18126 KALABASH RD

SOIL/SITE EVALUATION
for ON-SITE WASTEWATER SYSTEM

Re: Application for improvement permit for Richard Hagemeyer
Property Site: lot 3, Kalabash Road
Health Department file no. 4864B

Re: Detailed Soil/Site Evaluation on a ±10.0acre site (Lots 1 – 10) on the corner of Harbor View and Kalabash Roads, Mecklenburg County, NC.

SHEET 1 OF 1	SHEET TITLE: DETAILED SOILS EVALUATION	PROJECT NAME: R.H. HEGEMEYER, INC. - HARBOR VIEW - MECK. COUNTY, NORTH CAROLINA MAY 2002	S&EC Soil & Environmental Consultants, PA

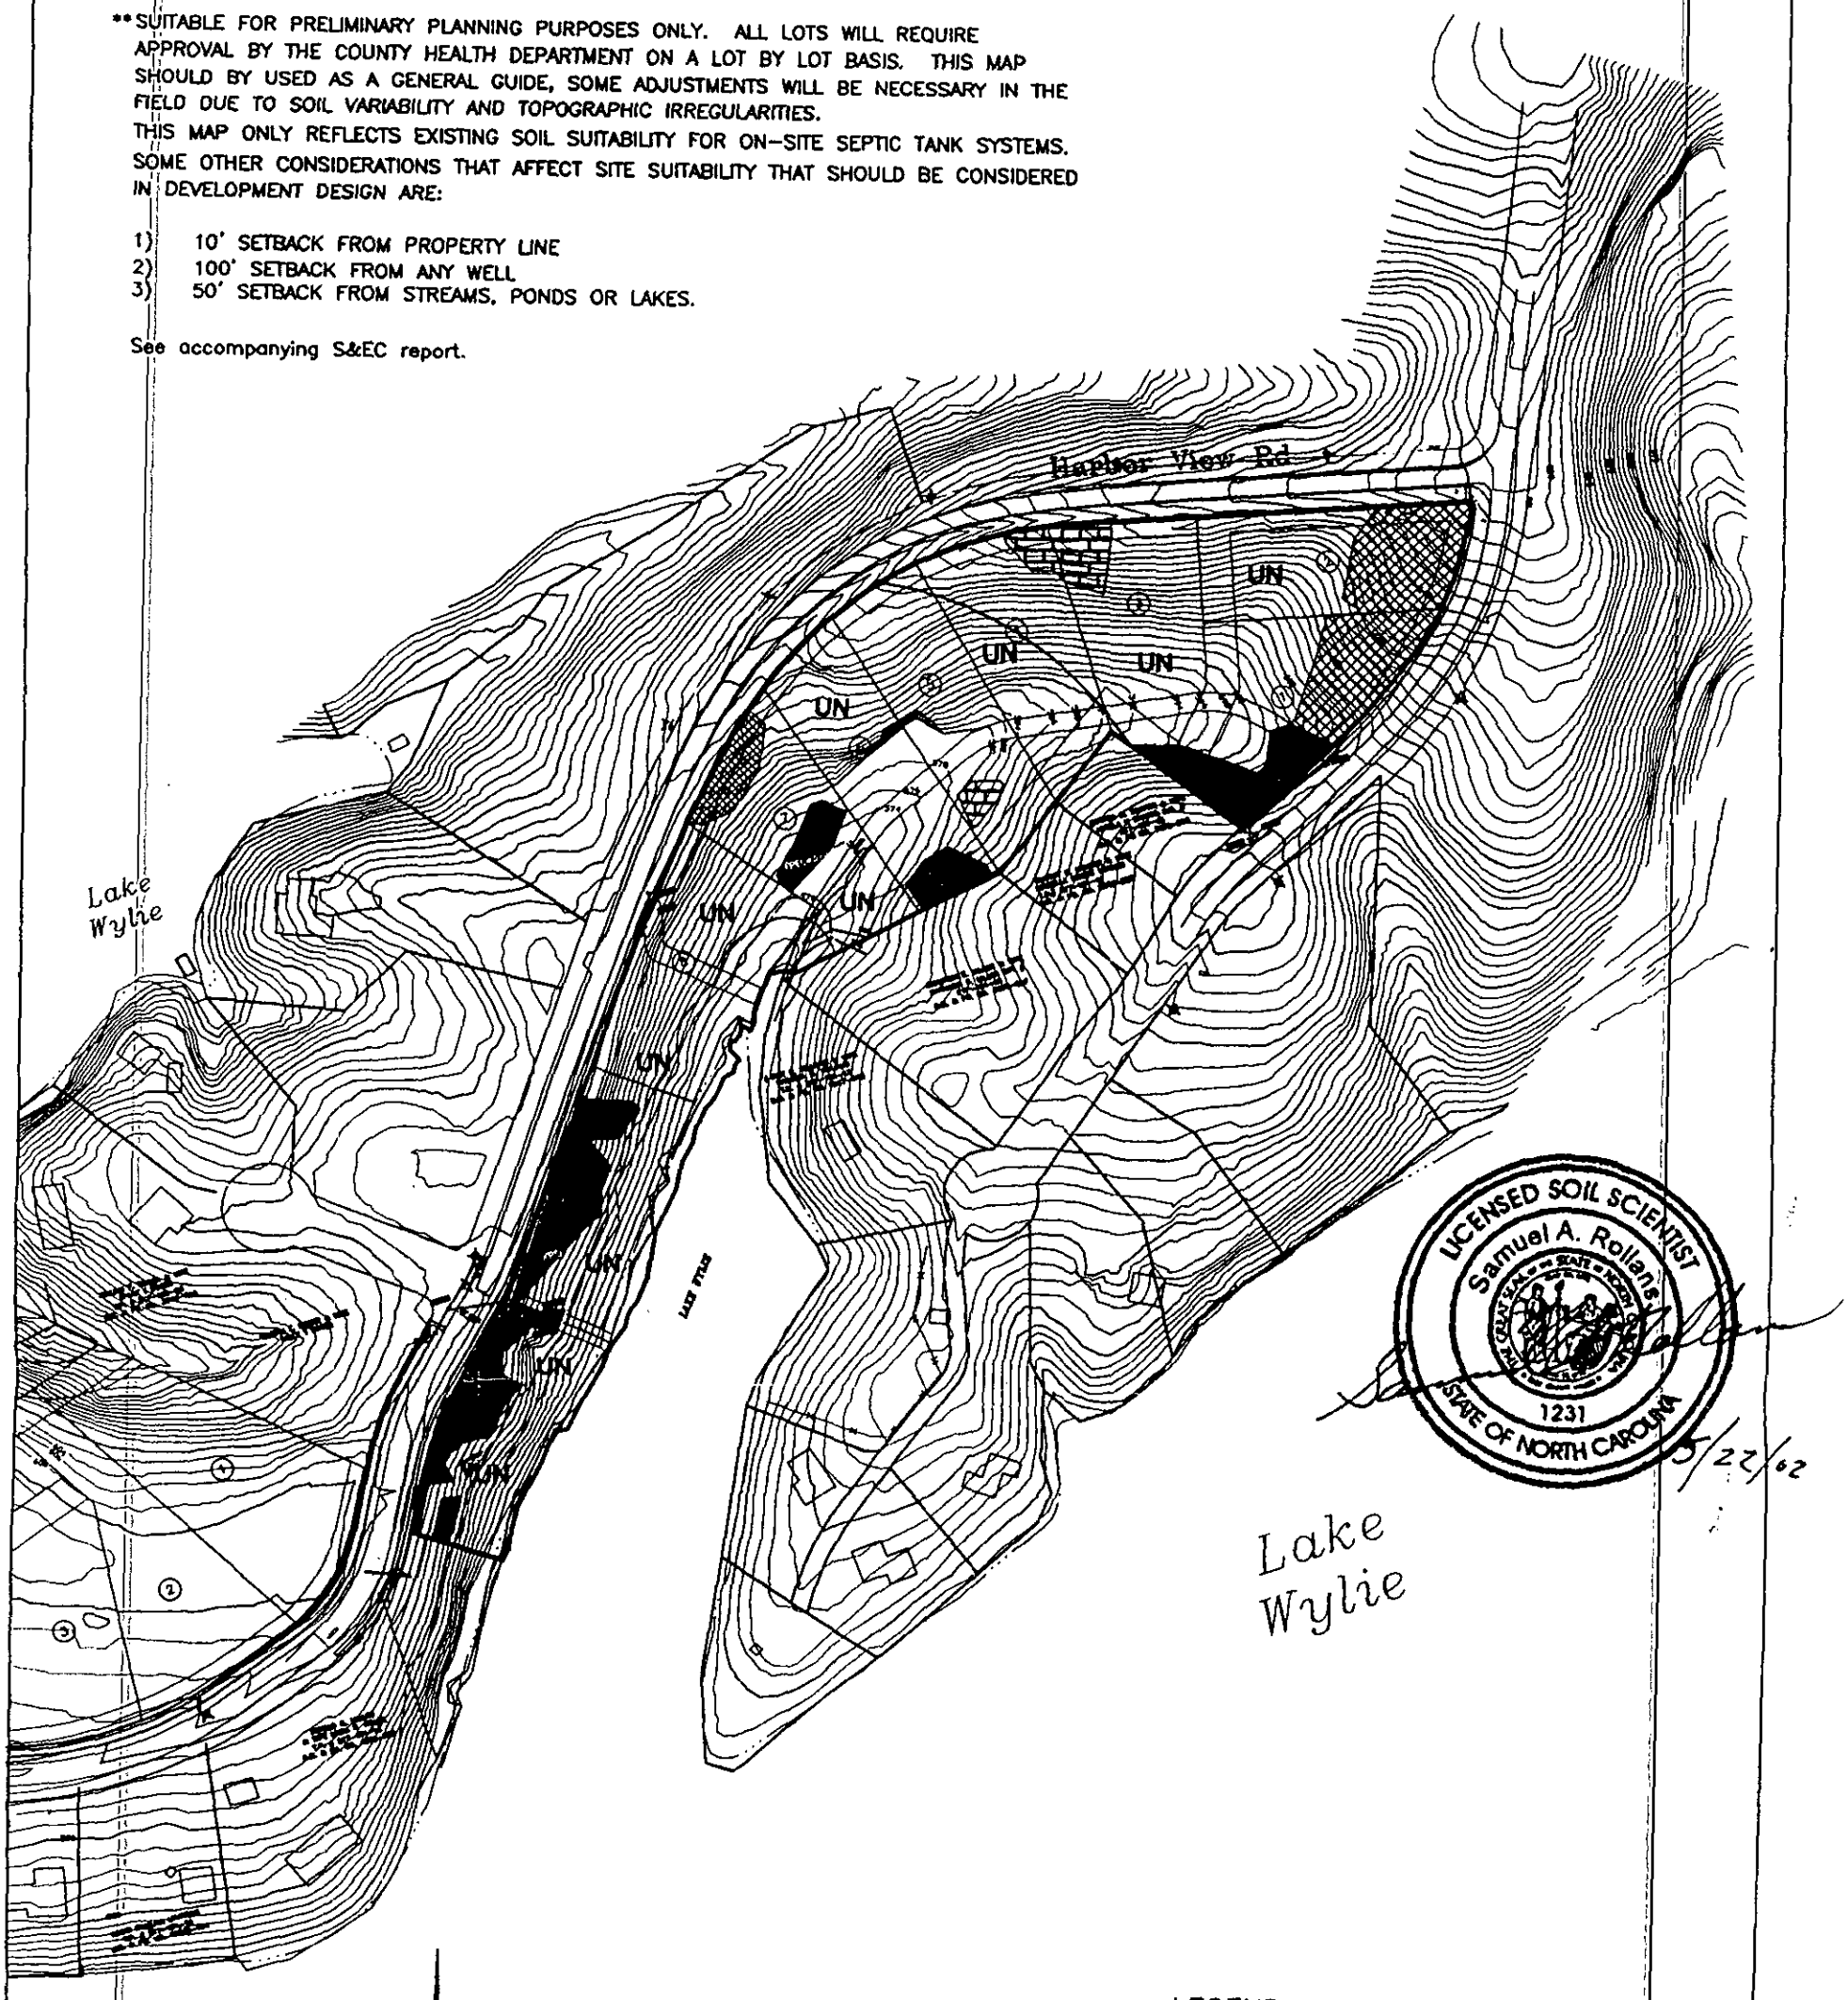
** SUITABLE FOR PRELIMINARY PLANNING PURPOSES ONLY. ALL LOTS WILL REQUIRE APPROVAL BY THE COUNTY HEALTH DEPARTMENT ON A LOT BY LOT BASIS. THIS MAP SHOULD BY USED AS A GENERAL GUIDE, SOME ADJUSTMENTS WILL BE NECESSARY IN THE FIELD DUE TO SOIL VARIABILITY AND TOPOGRAPHIC IRREGULARITIES.
THIS MAP ONLY REFLECTS EXISTING SOIL SUITABILITY FOR ON-SITE SEPTIC TANK SYSTEMS. SOME OTHER CONSIDERATIONS THAT AFFECT SITE SUITABILITY THAT SHOULD BE CONSIDERED IN DEVELOPMENT DESIGN ARE:

1) 10' SETBACK FROM PROPERTY LINE
2) 100' SETBACK FROM ANY WELL
3) 50' SETBACK FROM STREAMS, PONDS OR LAKES.

- Areas contain soils with 30 inches or more of useable material and have potential for conventional and shallow conventional septic systems.
- Areas contain soils with 24 to 30 inches of useable material and have potential for low pressure pipe (lpp) or "at-grade" conventional septic systems.
- Areas contain soils with ~~24 to 30~~ 18-24 inches of useable material and have potential for ~~low pressure pipe (lpp)~~ lpp or "at-grade" ~~conventional~~ septic systems.
- UN — Unsuitable areas.
